**Flight Design general aviation GmbH**

**SB-ASTM-CTSW-16**

# Service Bulletin

## Repair procedure to additional wires protection

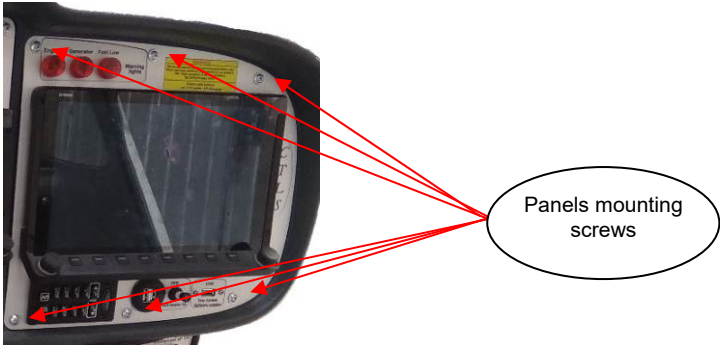
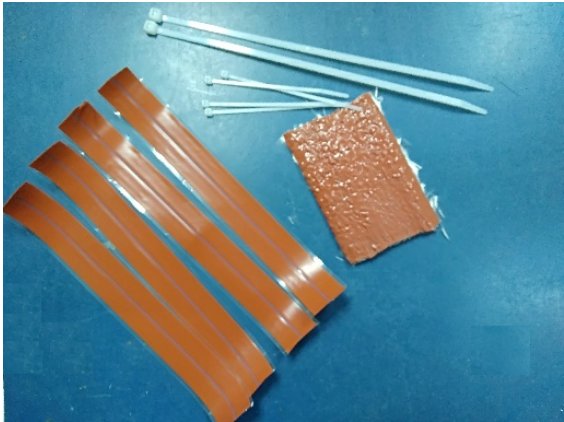
Step	Action	Reference
1	<p>Remove Panel Right section. Unscrew panel mounting screws.</p> 	
2	<p>Open additional wires protection set.</p> 	
3	<p>Pull out the wires as much as possible.</p>

4

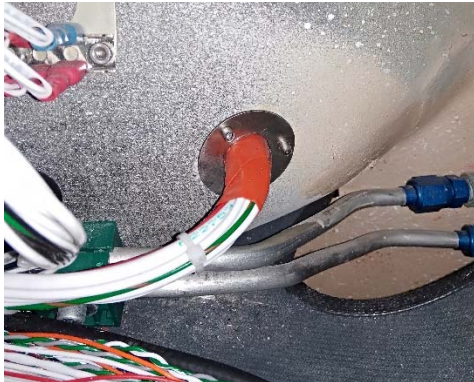
Remove the protective film from pyrosil tape. Wind the pyrosil tape around the wires\*.

\*Installation: Stretch tape during installation using at least a 50% overlap. For best results, use on clean, dry surfaces free from dirt and oil.

The protective layer must be at least 5 layers.

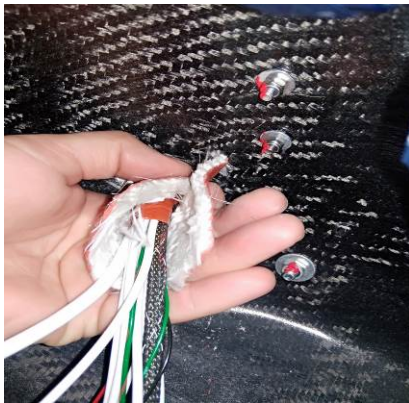
Wrap fire protection hose around flange and wires. Tighten TY-wraps around flange and wires.
